## UNITED STATES PATENT AND TRADEMARK OFFICE

APPLICATION NO.	FILING DATE	FIRST NAMED INVENTOR	ATTORNEY DOCKET NO.	CONFIRMATION NO.
10/776,203	02/12/2004	Rajiv Yadav Ranjan	50103-553	2760
7590	04/24/2009			
MCDERMOTT, WILL & EMERY 600 13th Street, N.W. Washington, DC 20005-3096			EXAMINER	
			MCDONALD, RODNEY GLENN	
ART UNIT	PAPER NUMBER			
	1795			
MAIL DATE	DELIVERY MODE			
04/24/2009	PAPER

<b>Office Action Summary</b>	<b>Application No.</b> 10/776,203	<b>Applicant(s)</b> RANJAN ET AL.
	<b>Examiner</b> Rodney G. McDonald	<b>Art Unit</b> 1795

## DETAILED ACTION

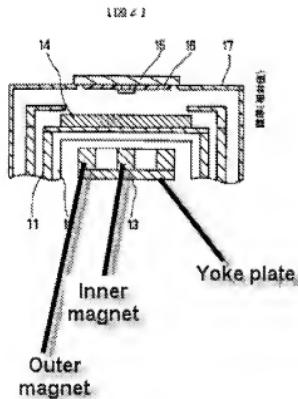
Regarding claims 27, 28, Akiyama et al. teach the outer diameter of the magnetron magnet to be 200 mm and 120 mm respectively. It would follow that the inner diameters would be less than 200 mm and less than 120 mm because of the showing in Fig. 2. (See Abstract; Fig. 2)

Regarding claims 31 and 32, Akiyama et al. teach the outer diameter of the magnetron magnet to be 200 mm and 120 mm respectively. It would follow that the inner diameters would be less than 200 mm and less than 120 mm because of the showing in Fig. 2. (See Abstract; Fig. 2)

Akiyama teach in Fig. 2 an annular shaped magnetron assembly. From Figure 2 it appears that there is an outer ring shaped magnet and an inner magnet on a disk yoke. See annotated Figure 2 below.
